AGENDA

NORTHERN BEACHES LOCAL PLANNING PANEL

WEDNESDAY 15 DECEMBER 2021

4.1 DA2021/1620 - 29-31 Moore Road, Freshwater - Alterations and additions to an existing pub (Harbord Hotel) 5

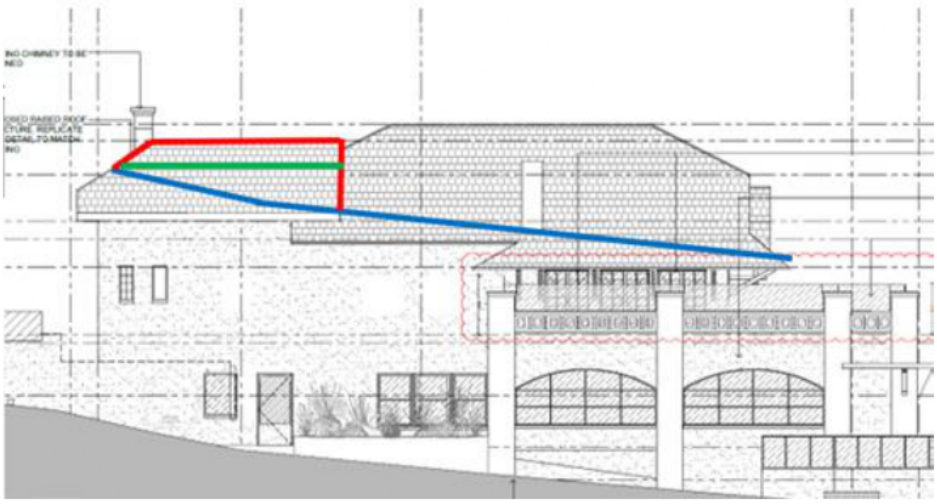
We note that the existing ridgeline in this location has been increased by 950mm to accommodate the lift shaft and associated overrun providing disabled access to the attic level of the development.

Figure 1 – Plan extract eastern elevation showing the height non-compliance based on ground level (existing). The blue line shows the 8.5 metre height standard, the red line the extent of proposed new works located above the height standard and the green line the existing building ridge height in this location.

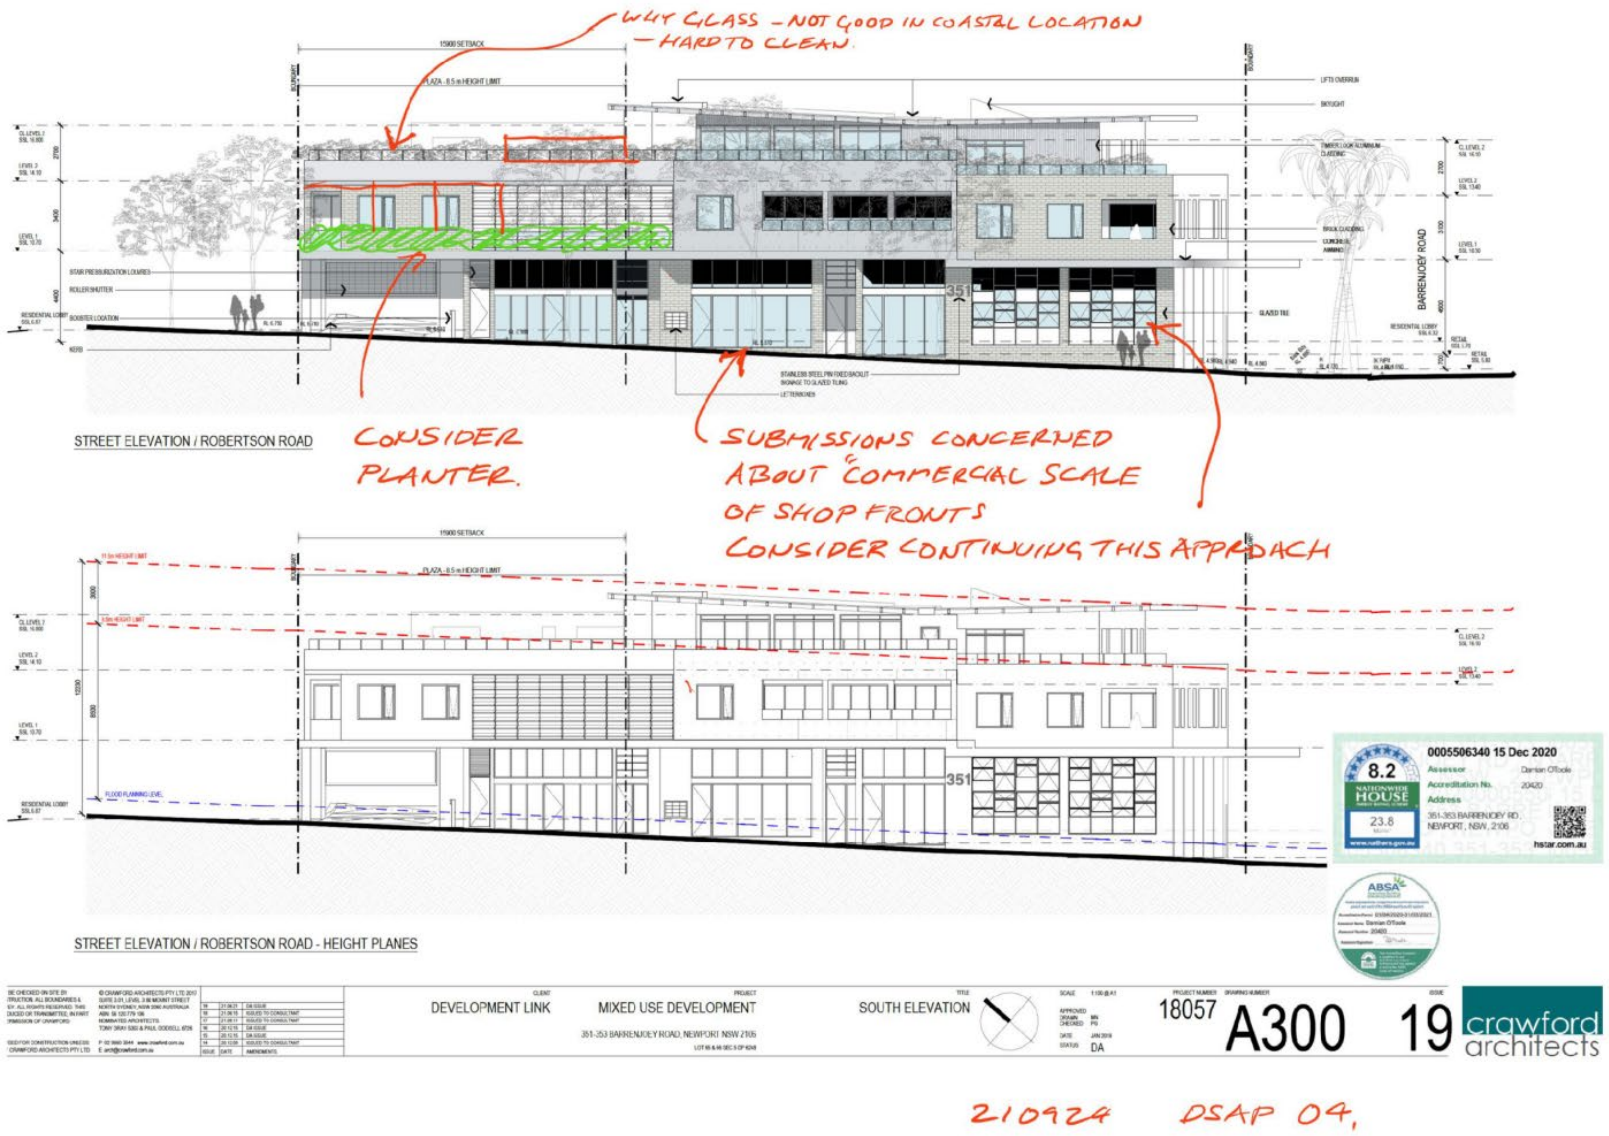
WHY GLASS - NOT GOOD IN COASTAL LOCATION - HARD TO CLEAN.
STREET ELEVATION / ROBERTSON ROAD
CONSIDER PLANTER.
SUBMISSIONS CONCERNED ABOUT "COMMERCIAL SCALE OF SHOP FRONTS
CONSIDER CONTINUING THIS APPROACH
STREET ELEVATION / ROBERTSON ROAD - HEIGHT PLANES
BARRENJOEY ROAD
351
0005506340 15 Dec 2020
8.2
23.8
DEVELOPMENT LINK
MIXED USE DEVELOPMENT
351-353 BARRENJOEY ROAD, NEWPORT NSW 2106
SOUTH ELEVATION
18057
A300
19
crawford architects
210924 DSAP 04,

Figure 4: Original development application, second floor layout, with extended built form towards the south-western corner of the site

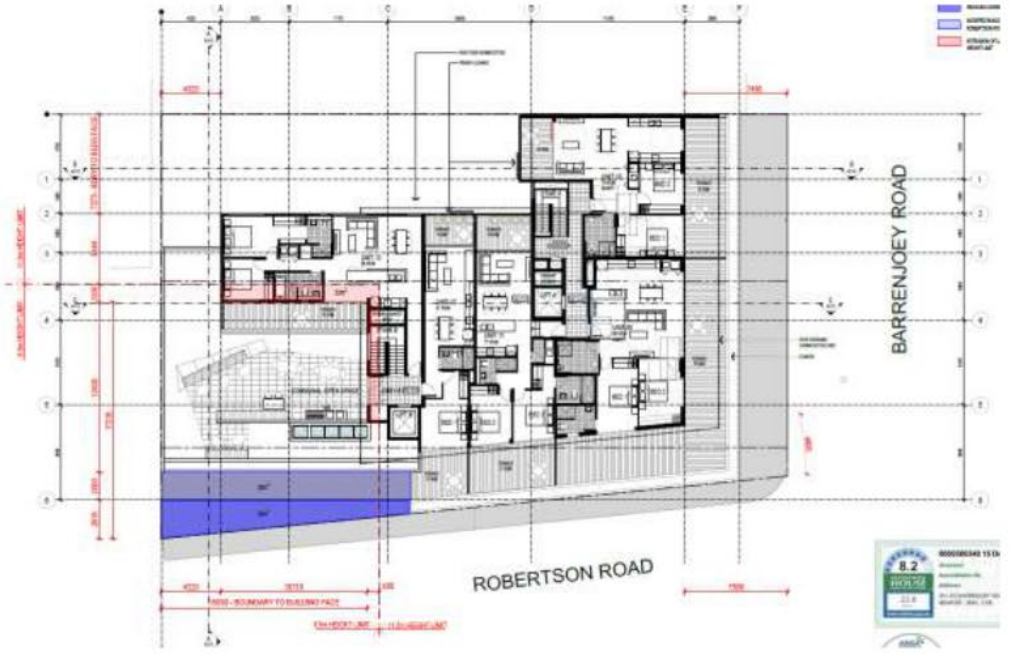
8. Figure 3, below, demonstrates the amended layout of the proposed second floor, including that part of the proposal that exceeds the 8.5m height limit (shown in red). The extent of proposed building form at this part of the site has been significantly reduced (as demonstrated at Figure 4) in response to concerns raised about the loss of solar access that would otherwise occur to the public domain and associated shopfronts on the southern side of Robinson Road. This section of the building has been replaced with a common open space area that relies less on solid built form and thus reducing its impact to the south, such that it more appropriately aligns with the height limit than previously proposed.

West elevation
The west elevation includes two areas of envelope breach:

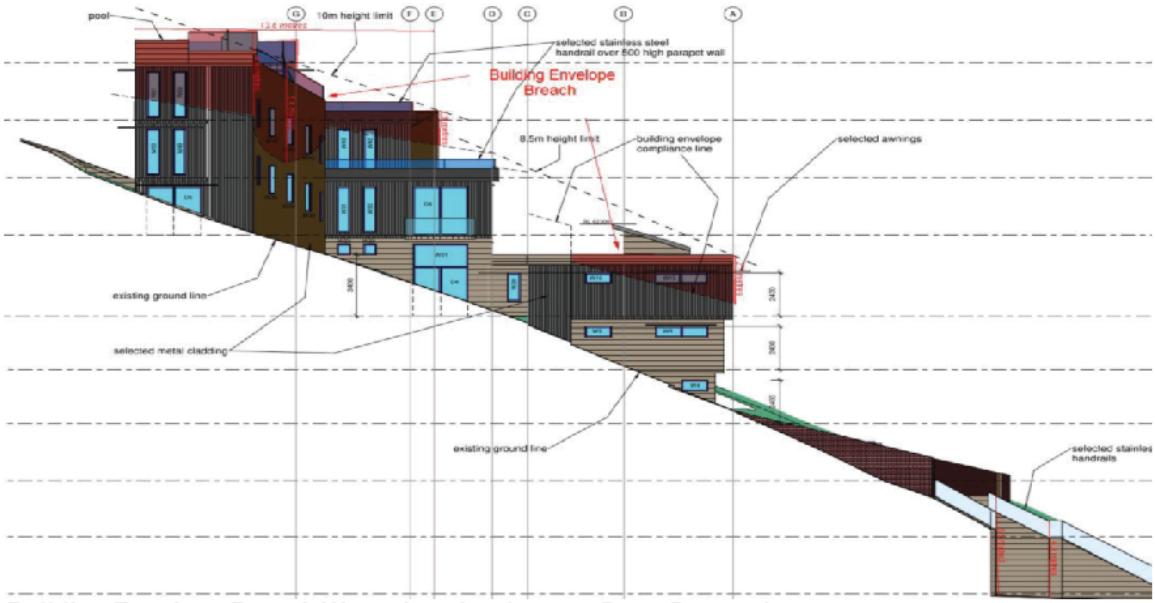
- studio / offices (0.5m - 2.8m in height x 7.6m in length), and
- dwelling (1.3m - 5.4m in height x 13.6m in length), refer to image below.

Figure 1: *Reduction in building height shown in red.*

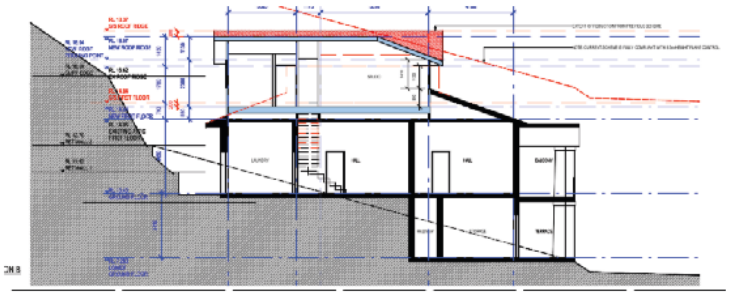
As a result, amended plans were received that reduced the overall building height from RL18.37 to RL18.07 - RL17.17 to comply with the height of building standard of 8.5m. See figure below.

Figure 9: *North Elevation wall height non- compliance shown in pink (additional wall height due to gable roof design).*

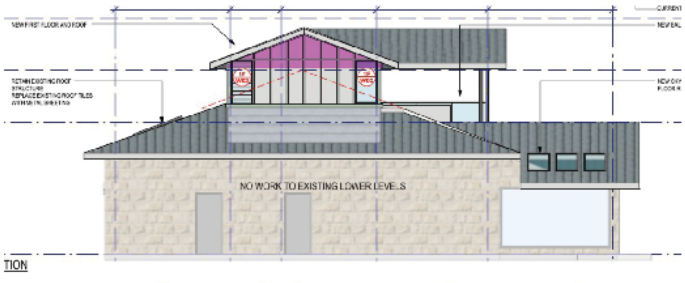
The figure below shows the wall height variations (indicated in pink) and the storey non-compliances (indicated in red).
